GTS Newsletter

2008/06E

Machine	TASKI swingo XP
Subassembly	Chassis

Squeegee Lowering Mechanism

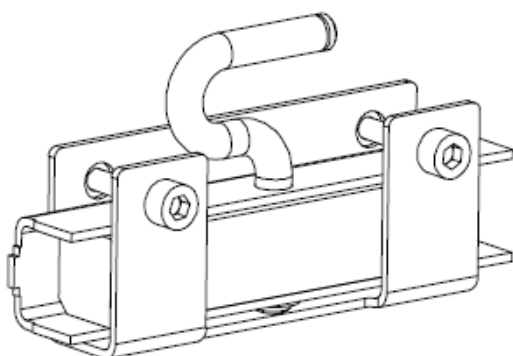
Feedbacks from the market have indicated that due to permanent moving of the bolt the squeegee lowering mechanism can extend and damage the relevant passage in the chassis. Because of this reason a set which can be fitted into the existing machines is now available.

The relevant strengthening of the chassis has been realised from machine no. 2410.

Description	Material Number	Status
Squeegee lowering mechanism modification set	4127903 (18603-32)	available
Remarks	-	-

When doing a regular service on a TASKI swingo XP we recommend a thoroughly visual examination of the chassis. If the first signs of damage are visible the modification set has to be mounted.
